**CITY OF CONDON
WORK SESSION AGENDA
PLANNING COMMISSION 11-17-2020
Tuesday, November 17, 2020, 5:30 PM
CONDON CITY HALL**

Reference: Condon Grade School Site Plan Review Staff Report

City of Condon, Oregon
Grade School Site Plan Review Submittal
City Engineer Report
November 12, 2020

EXISTING CONDITIONS
SCALE: 1"=30'

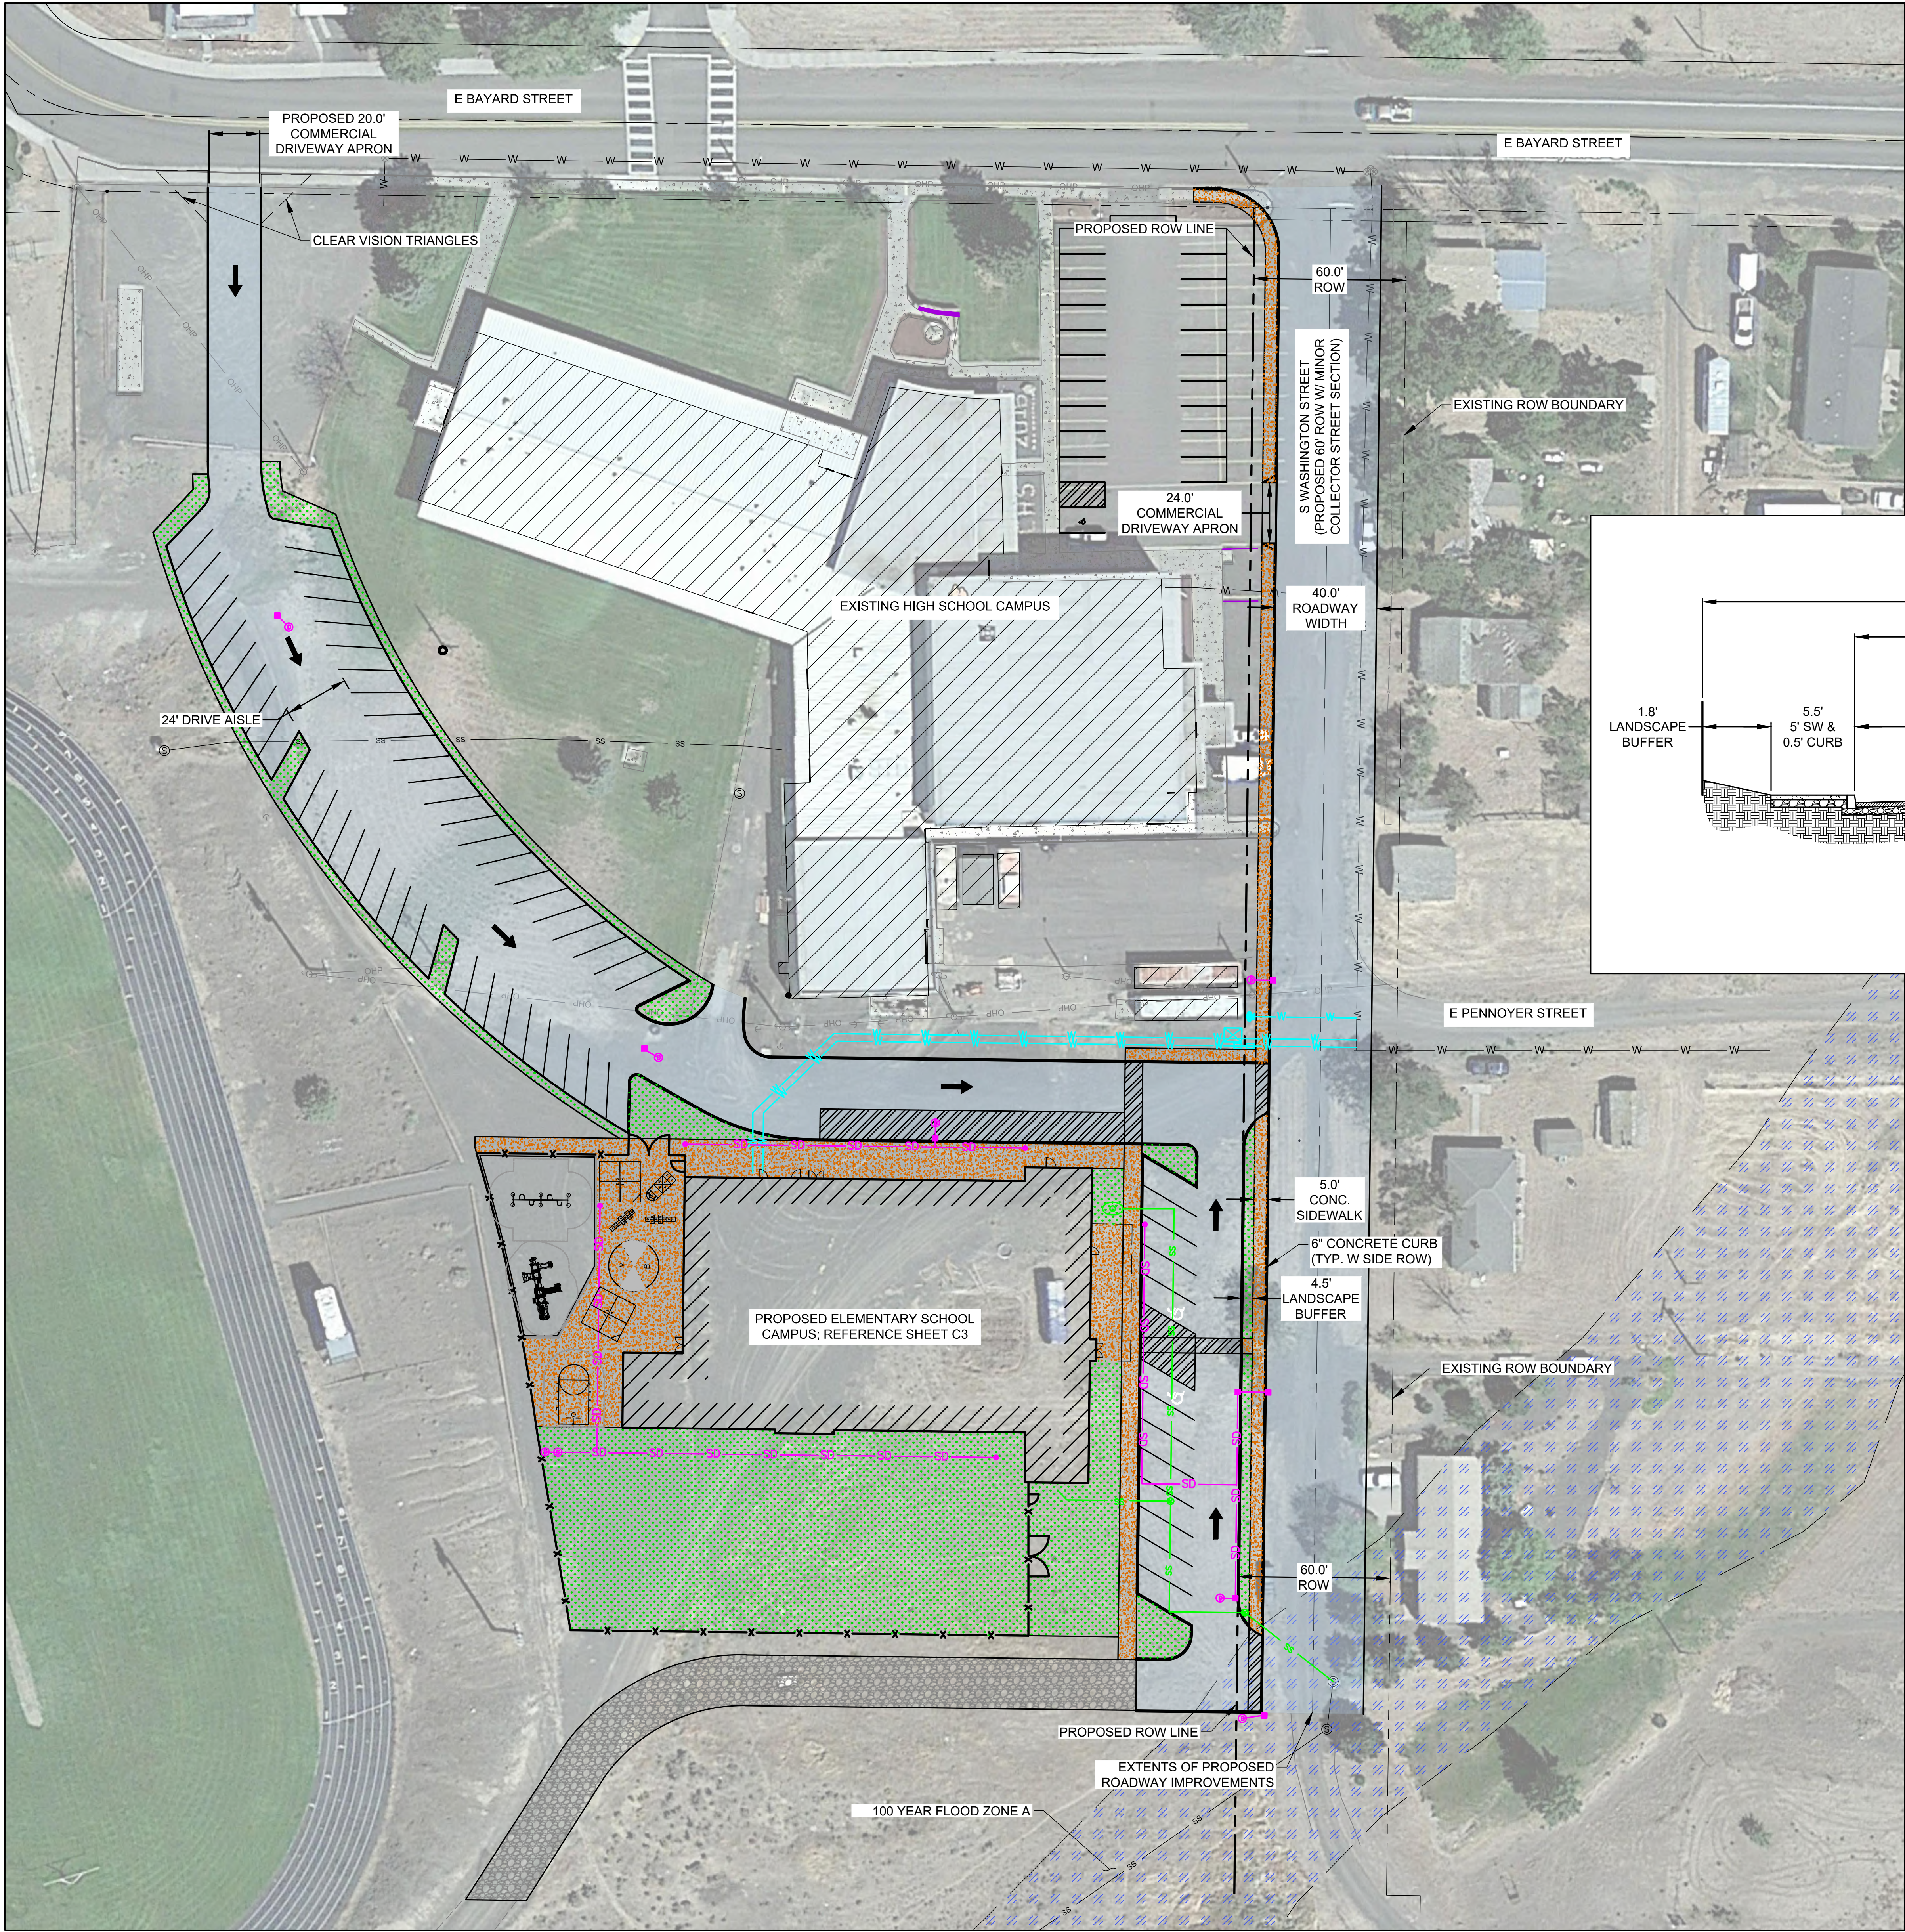
- C1 The callouts on the Drawing and key notes should be reconciled (i.e., some key notes do not match what is being pointed to).
- C1 The full existing sewer alignment needs to be shown northeast of the existing manhole.

OVERALL SITE PLAN
SCALE: 1"=30'

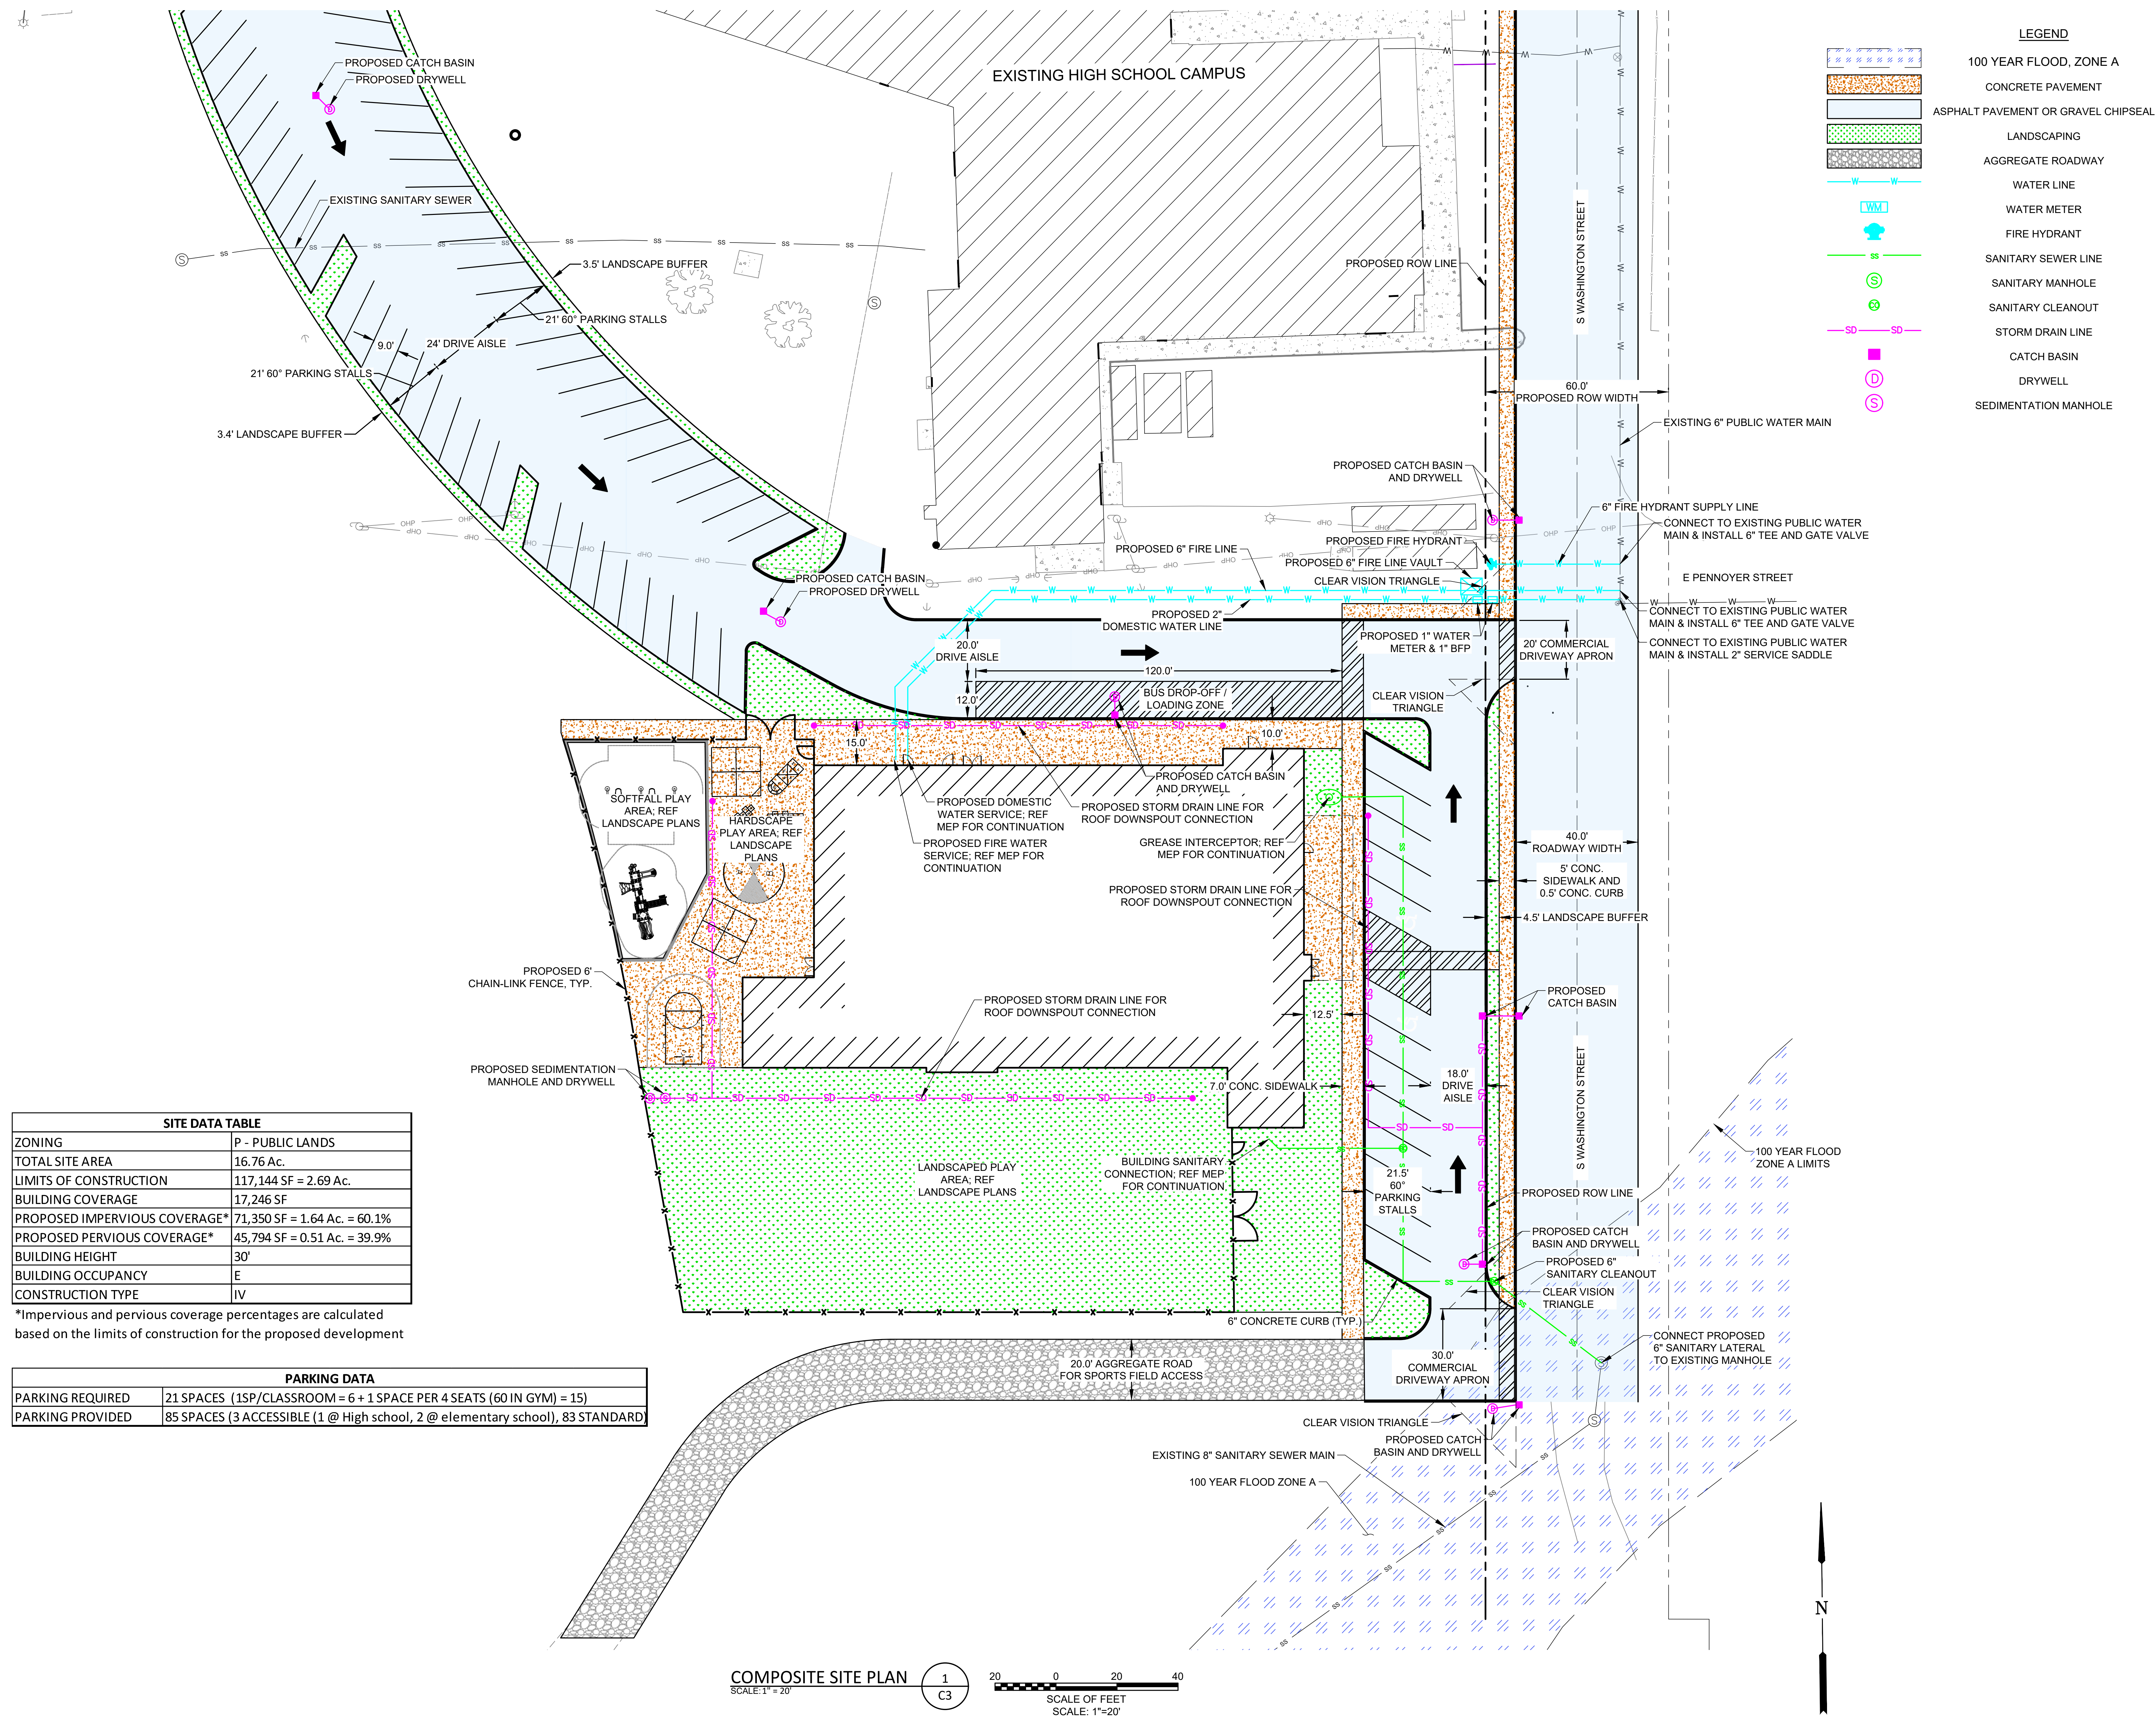
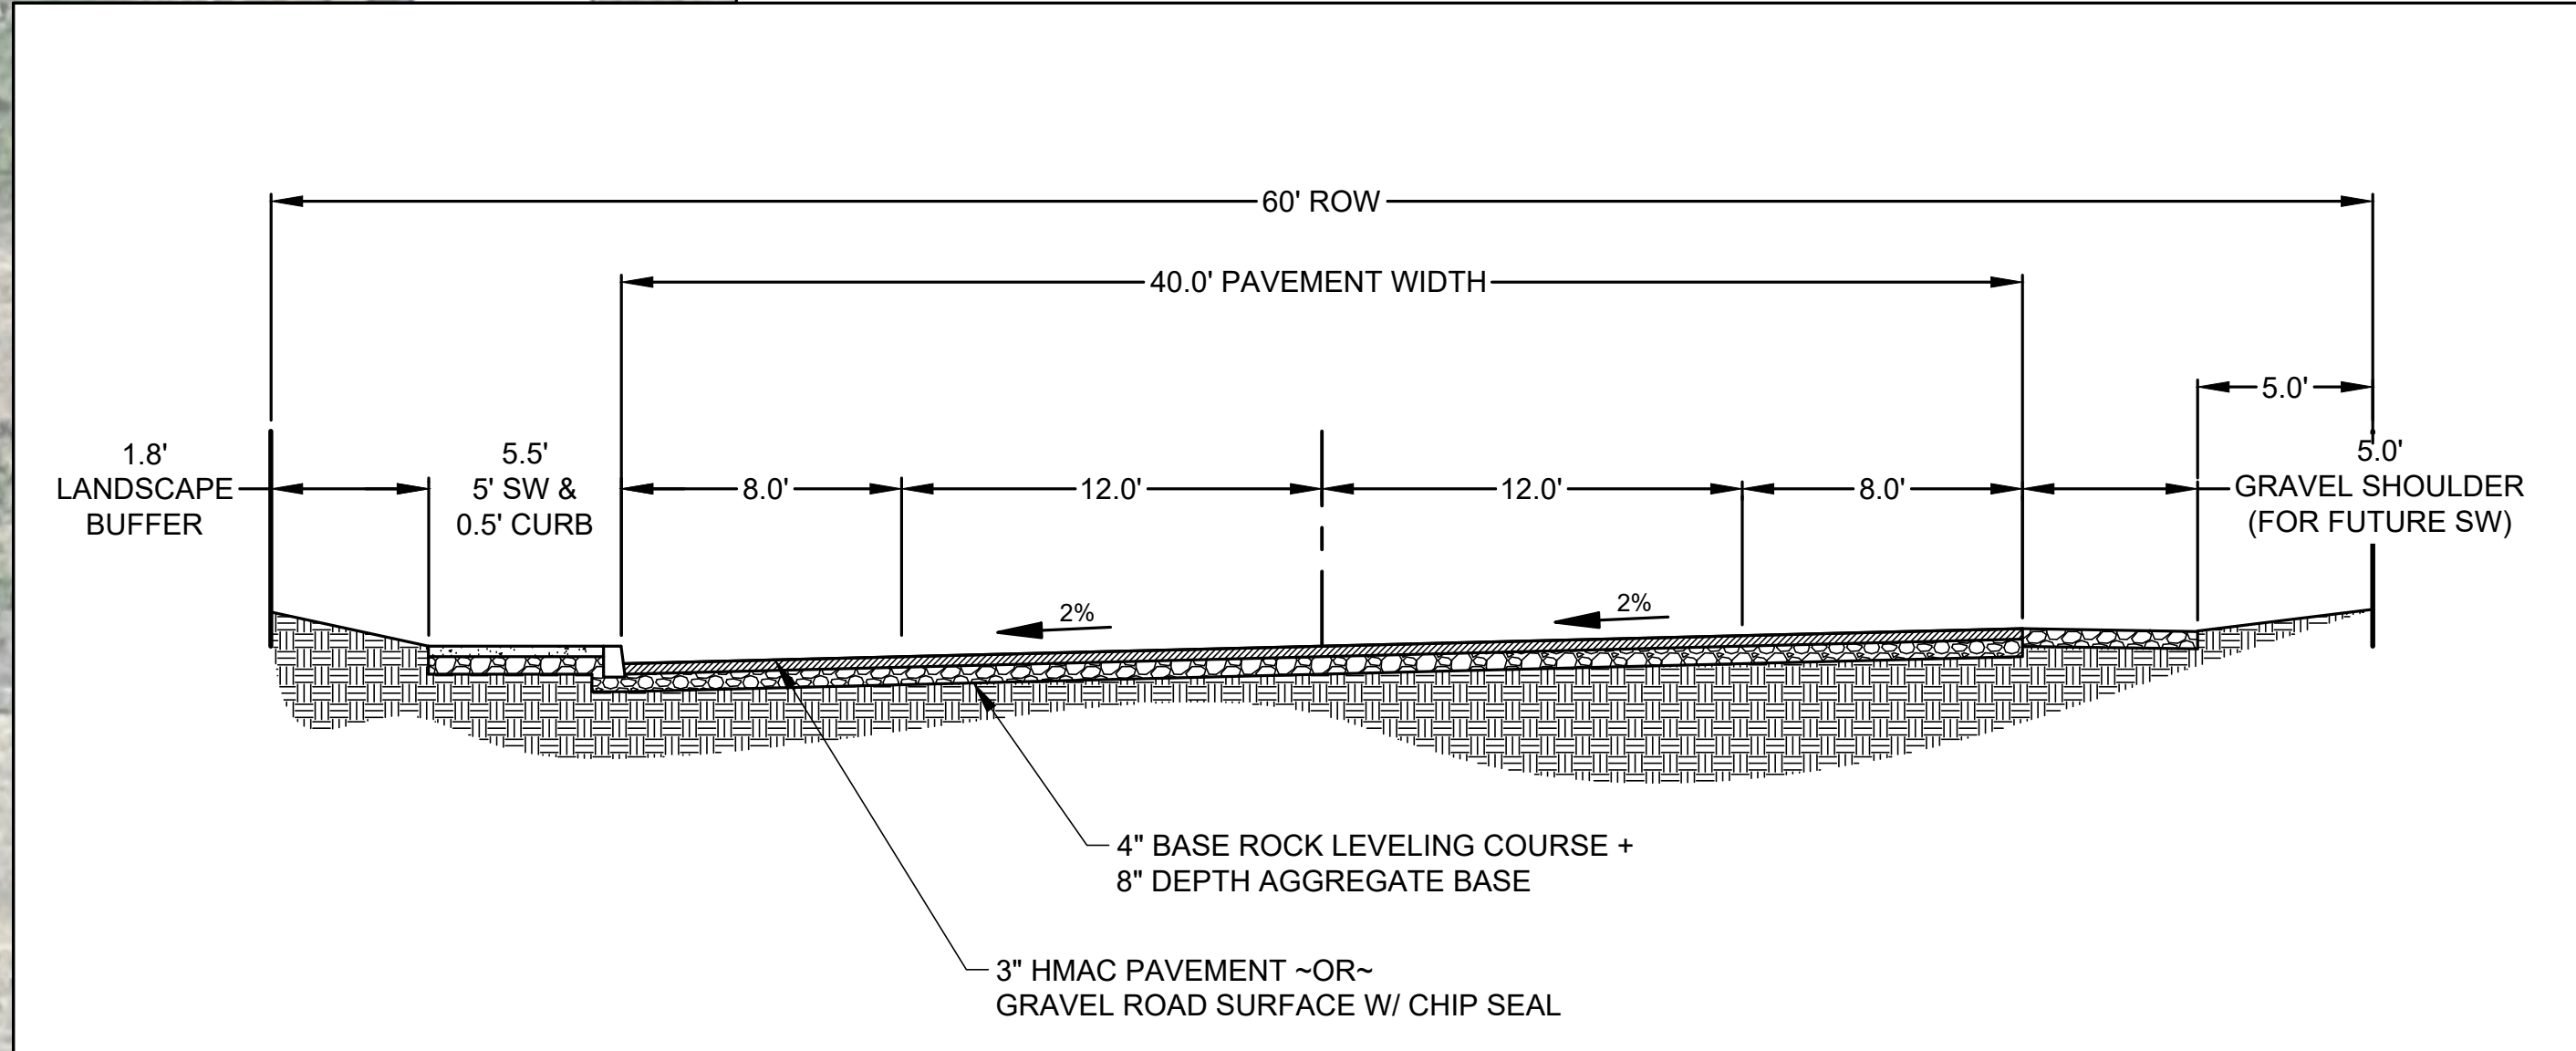
- C2 City standards require a 3-inch minimum depth of asphalt and potential need for geotechnical fabric under road aggregate base. The designer should provide pavement design showing adequacy of existing road section to accommodate existing and proposed traffic.

- C2 Gravel with chip seal is not an acceptable City road surface per City standards. Remove the reference to chip seal in the City ROW.
- C2 The proposed road termination on S. Washington Street is a concern. Will fire trucks, delivery trucks, etc., be able to turn around and head back north through the parking lot? In coordination with the City, we believe it may be best to close access to E. Trimble Street via S. Washington Street via semi-permanent ecology block barricades with reflective striping.

- C2 The proposed narrowing of the one-way parking lot off E. Bayard Street may require modification of existing state highway sidewalks and curbs as well as gravel parking access to the adjacent swimming pool. Clarify the intent of this improvement.

- C2 Clarify the proposed usage of the existing high school parking lot and the use of the existing connection to E. Bayard Street. The Oregon Department of Transportation (ODOT) is preparing to make Americans with Disabilities Act (ADA) improvements in this area, but no improvements to replace the existing parking lot driveway access are included in ODOT's plans. The school will need to address sidewalk and curb improvements if the existing parking lot access is abandoned.

- C2 Clarify how existing high school accesses (i.e., sidewalks, parking, entryways, etc.) are to be maintained east of the gymnasium.
- C2 Clarify how irrigation water service is to have backflow prevention provided and metered. Typically, the building service, in addition to the City system, needs backflow prevention from the irrigation service.

- C2 More details of proposed City utilities, connections, piping, etc., are anticipated with the permit set Drawings. Also, provide details on the water line thrust restraint with connections to the City water main.
